Consultation Response from KC, Highways Development Management (HDM)		
2021/93689 Land to the south of Ravensthorpe Road / Lees Hall Road, Dewsbury		
Hybrid application for full planning permission for engineering works, drainage and utilities connection for the provision of site access from Forge Lane and Ravensthorpe Road and associated works; and for outline permission for erection of residential development and mixed use development (including community facilities) with associated works including the provision of internal estate roads and parking, landscape works (including provision of public open space, tree clearance/replacement/woodland management and ecological management) and sustainable urban drainage works drainage principles		
Date Responded: 14/12/21	**Responding Officer:** A Darwin	**Responding Ref:** HDC 16-14NW/8

RECOMMENDATION: Further information required

CHANGE IN JUNCTION FLOWS FROM SYSTRA SATURN MODEL - 2030 BASE + 500 UNITS AT DEWSBURY RIVERSIDE (AM Top Figure/PM Bottom Figure)

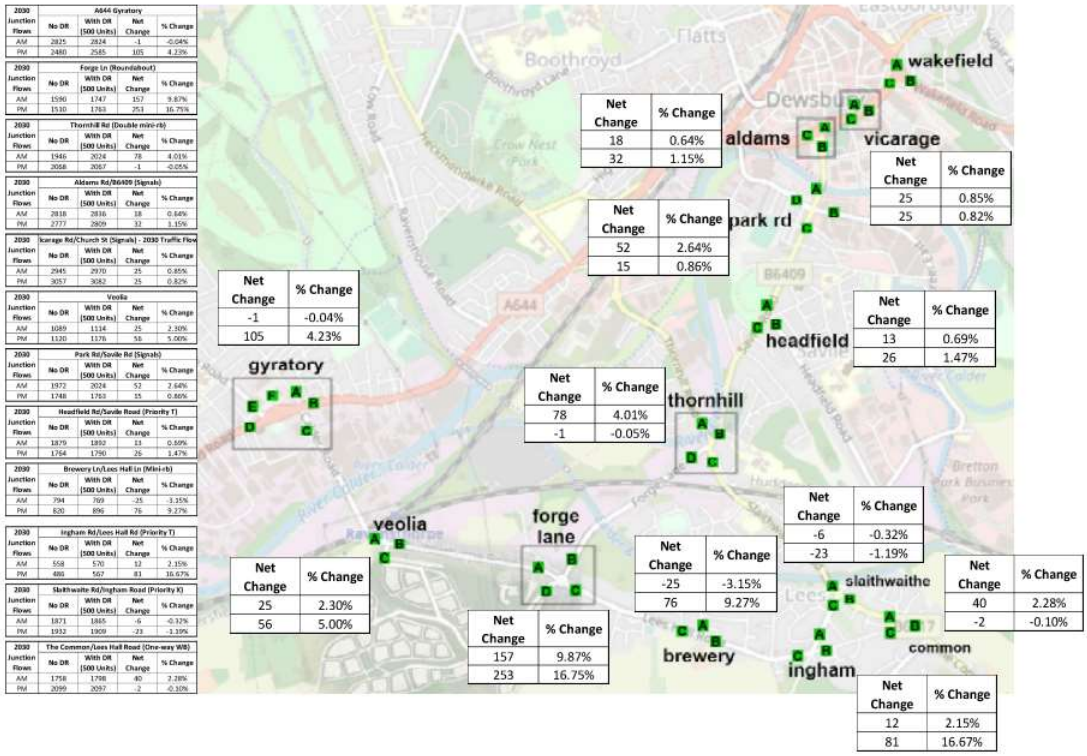
As can be seen from the data, the data appears to show some unexpected results, some of which are identified below:

- At the A644 gyratory, the introduction of Dewsbury Riverside development traffic reduces the junction flows by -1 vehicle in the AM peak;
- At the Thornhill Rd Double Mini-roundabout, the introduction of Dewsbury Riverside development traffic reduces the junction flows by -1 vehicle in the PM peak;

- At the Brewery Lane/Lees Hall Lane priority junction, the introduction of Dewsbury Riverside development traffic reduces the junction flows by -25 vehicles in the AM peak;

- Given that all development traffic would need to pass through either the A644 gyratory, the Thornhill Rd Double Mini-roundabout or the Brewery Lane/Lees Hall Lane mini-roundabout junction, it would be expected that the total increase in flow at these junctions would be the same as the total derived development traffic flows. However, this is not the case, with the net increase in flows at the three junctions being +52 (-1 + 78 – 25 = +52) in the AM peak, which should be more like +240 vehicles (e.g. AM two-way trip rate of 0.479 x 500 units = +240).

In light of the above, it appears that there is an issue with either the 'base' or the 'with development' traffic data. Unfortunately the TA provides no information regarding the methodology or assumptions included within the SATURN model assessment to understand why these issues have arisen. However, it is assumed that these issues have occurred as a result of some of the base traffic flows being displaced to other routes by development traffic within the area wide SATURN model.

Whilst HDM acknowledges that some element of traffic displacement may occur and it is appropriate to take this into account when assessing a network at a strategic level, it does not provide a robust basis for assessing the impact of a single development on individual junctions local to a development site. Instead an assessment should be undertaken that includes a static baseline traffic flow scenario (e.g. the 2030 SYSTRA baseflows), and compares this to the additional impact of Phase 1 Dewsbury Riverside development traffic, without any displacement of base traffic. This should be possible by either obtaining the Dewsbury Riverside Phase 1 traffic flows in isolation from the SATURN model

(these would then need to be factored from 500 to 350 units) or by assessing development traffic flows manually and utilising a more conventional census based traffic distribution (e.g. the approach taken for the previous Miller Homes applications at the Dewsbury Riverside site).

It is concluded that the traffic modelling as currently presented does not provide a robust basis for assessment, and a revised assessment approach and traffic modelling data should be provided for review.
